**E5515C-06B**

# **S E R V I C E                      N O T E**

## **E5515C Wireless Communications Test Set (8960 Series)**

### **Boot Up Failures at Power-On Require Replacement of 10 GB Hard Disk Drive (HDD)**

**Figure 1 – HDD failure during test set power-on (BSP code not loaded from HDD to RAM).**

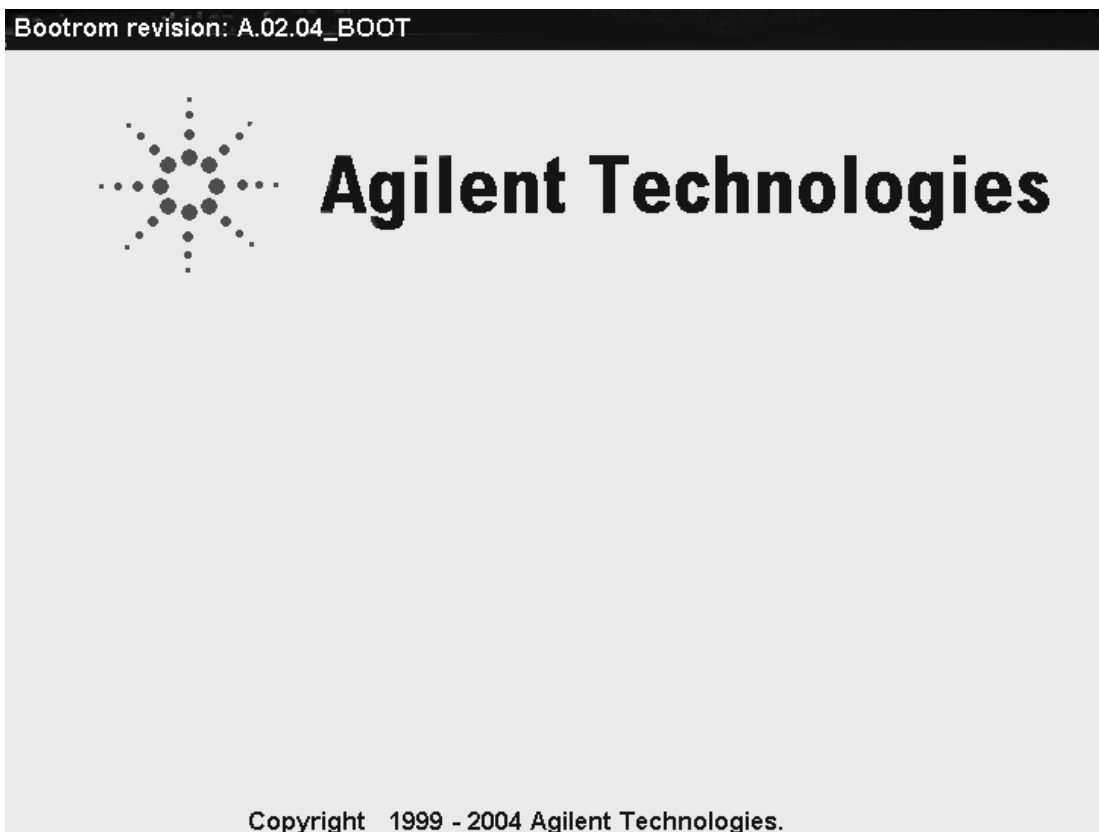
- **Figure 1** shows the typical point in the test set bootup process where the HDD fails to initialize. Note that the BSP Revision code is not displayed in the upper right corner of the display. A typical failing 10 GB HDD will show this screen intermittently in the first stages of failure.

A defective Channel Control chip on the HDD control circuitry is the main source of failures. This chip controls the read/write function to and from the HDD. The failure mechanism is accelerated with elevated ambient temperature and humidity (above 80 deg F and 80% relative humidity). Replacement HDDs (20 GB) have been re-designed to correct this problem.

If the test set fails to bootup correctly replace the HDD using repair kit E5515-61833 (which uses a 20 GB HDD). You must provide the model number and serial number of the test set when placing an order for this repair kit.
